October 22, 2024

ADDENDUM #1

FAMU: CAMPUS CHW INFRASTRUCTURE – NORTH LOOP [PEG #223-131]

FILE: ME-3
JOB NO.: 223-131
DATE: 9/9/2024
PLOT SIZE: 1=1
DRAWN BY: CAH
CHECKED BY: R.A.
SHEET NO.: ME-3

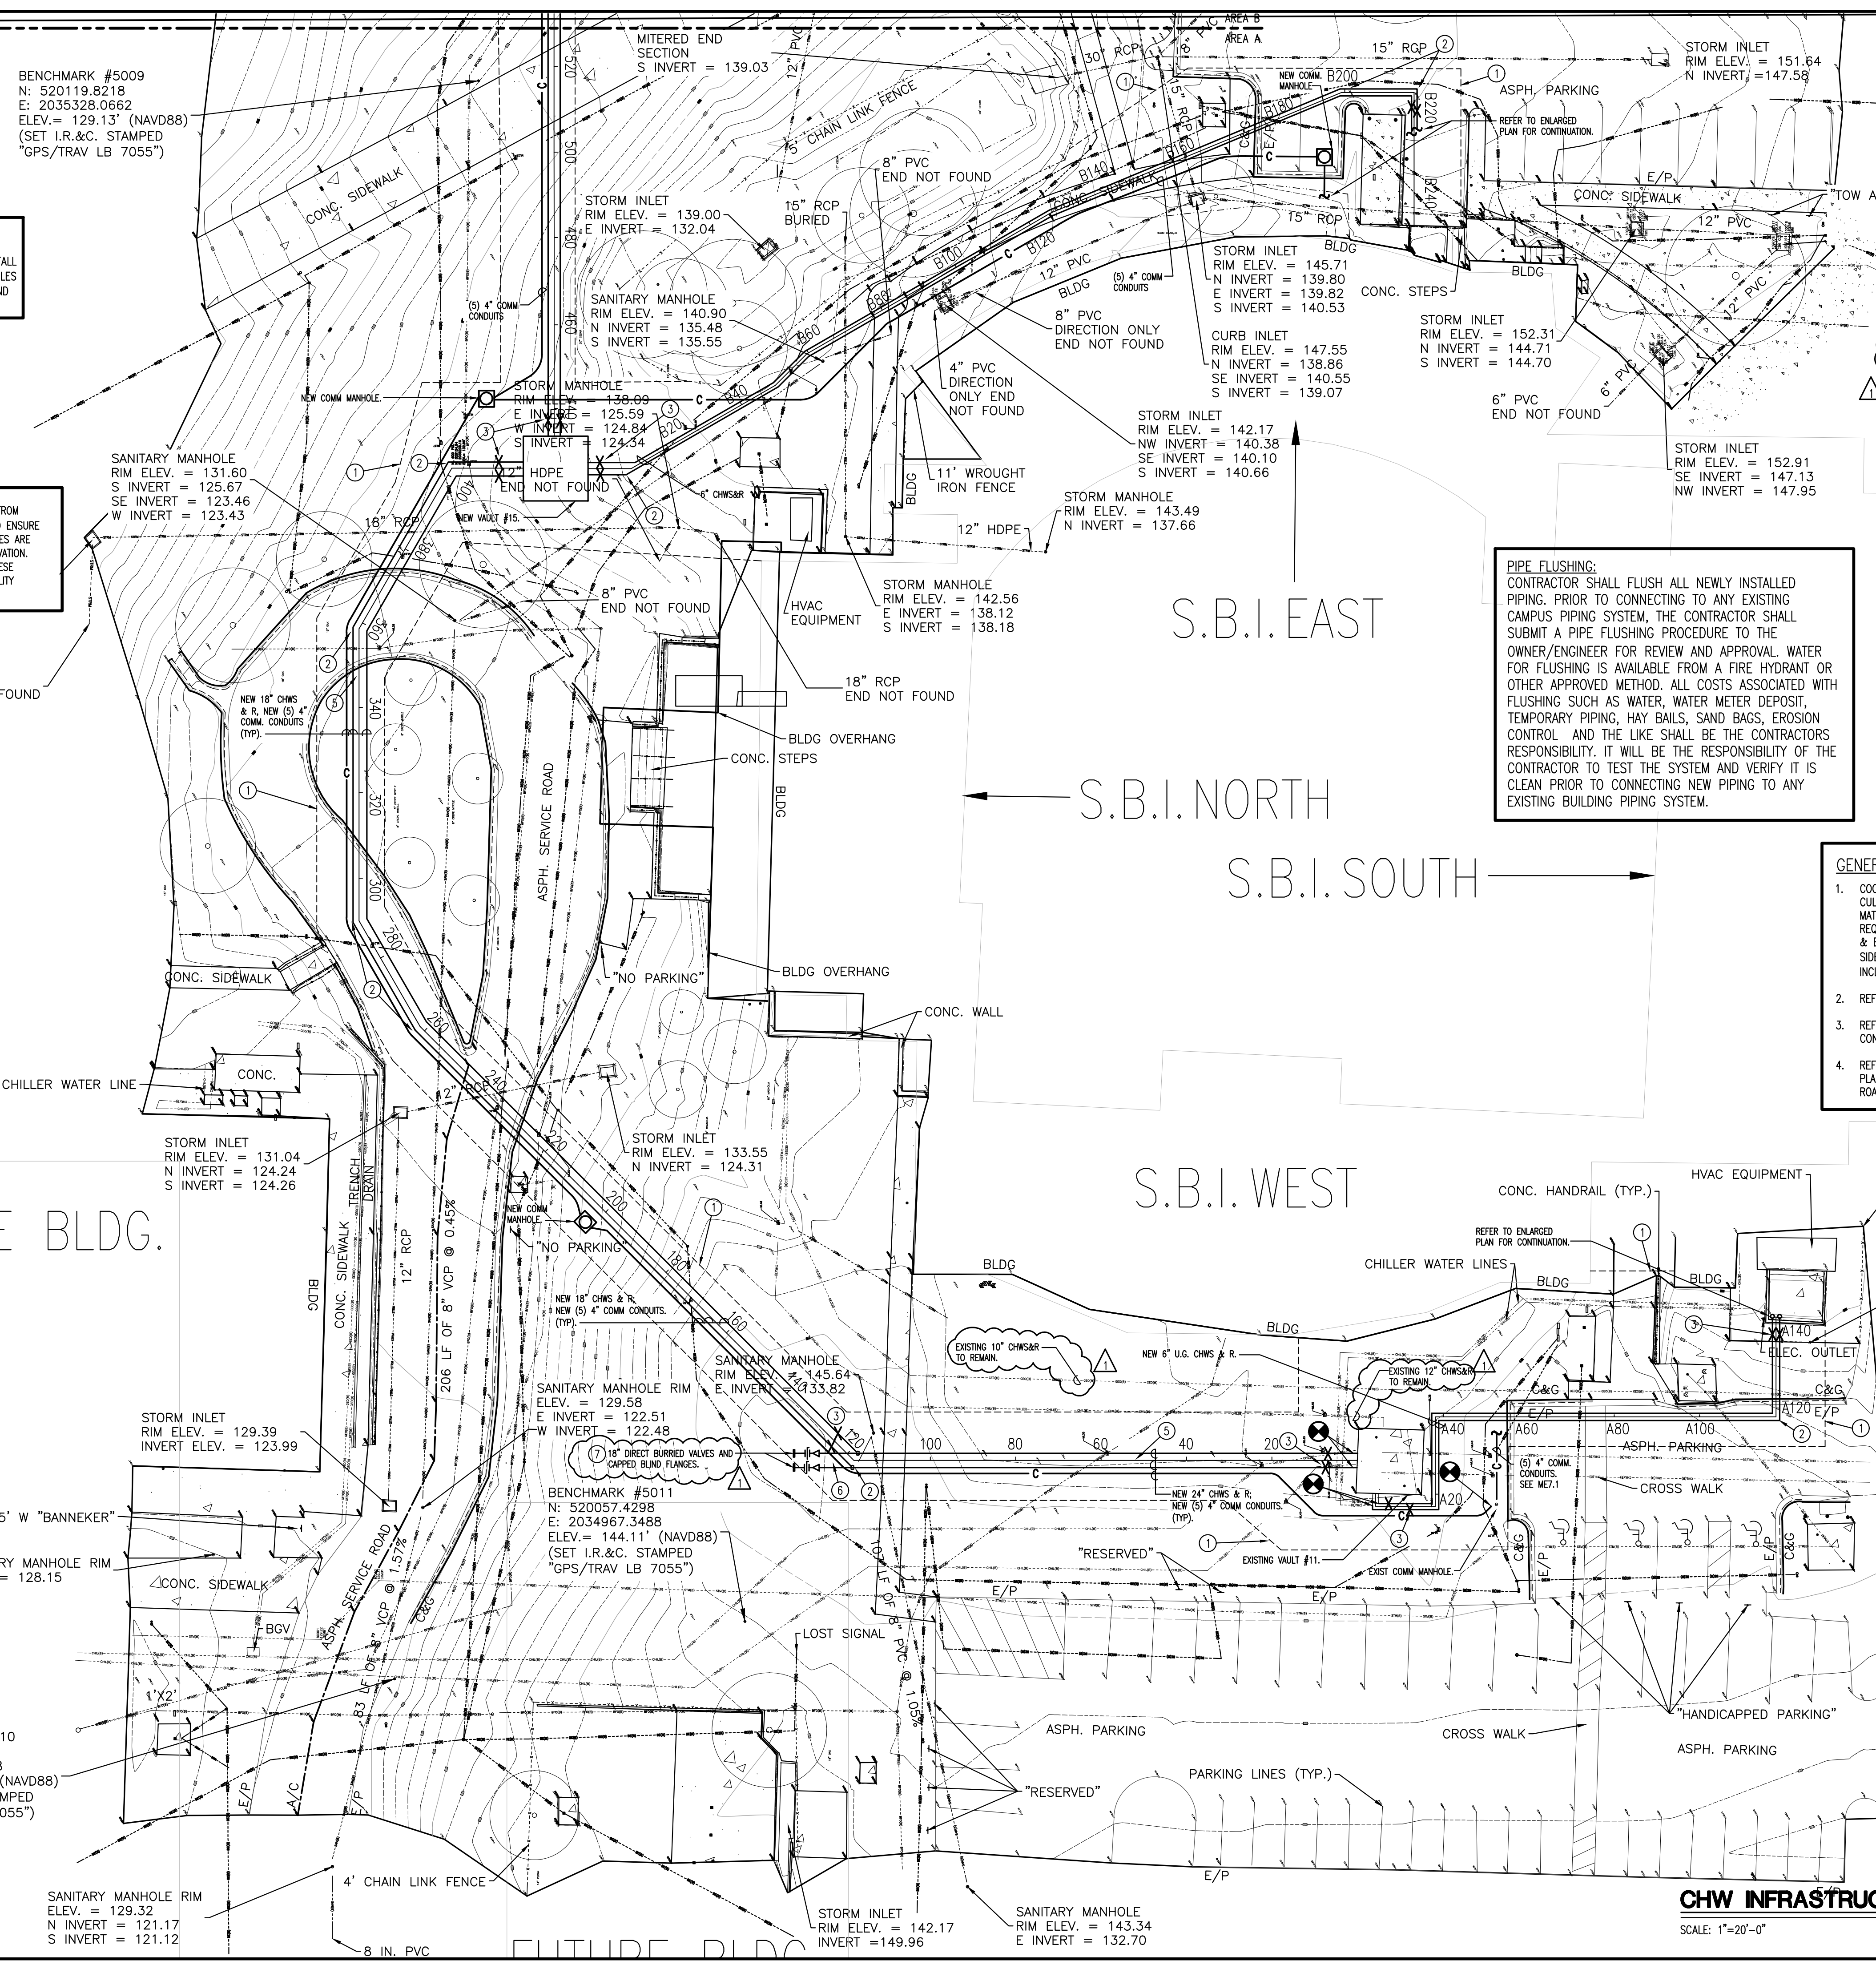
1. **SHEET ME-1.2:**
 - a. Added existing to remain HHW pumps to Pump Schedule.
 - b. Clarified HHW pumps on Variable Speed Drive Schedule.
2. **SHEET ME-3:**
 - a. Added Mechanical Work Note #7, clarifying direct bury valve requirements.
 - b. Added note #7 to sheet.
 - c. Clarified location of existing to remain CHW pipe.
3. Refer to attached Pre-bid RFI questions and responses.

- NEW UNDERGROUND AIR VENT BOX, REFER TO DETAIL AND PIPE PROFILE.
- CHWS/ISOLATION VALVES - M&H VALVE W/CS/IS OR APPROVED EQUAL, FULL BODY CAST IRON RESILIENT WEDGE VALVE, EPOXY COATED, 18" FLANGED ENDS WITH ZINC COATED BOLTS AND NUTS, NON-RISING STEM WITH SQUARE OPERATING NUT, EXTENDED STEM (AS REQUIRED WITH PROTECTIVE PIPING) AND INSULATE ENTIRE VALVE ASSEMBLY WITH CANUSA INSULATING KIT COMPATIBLE WITH U.G. PREINSULATED PIPING SYSTEM.
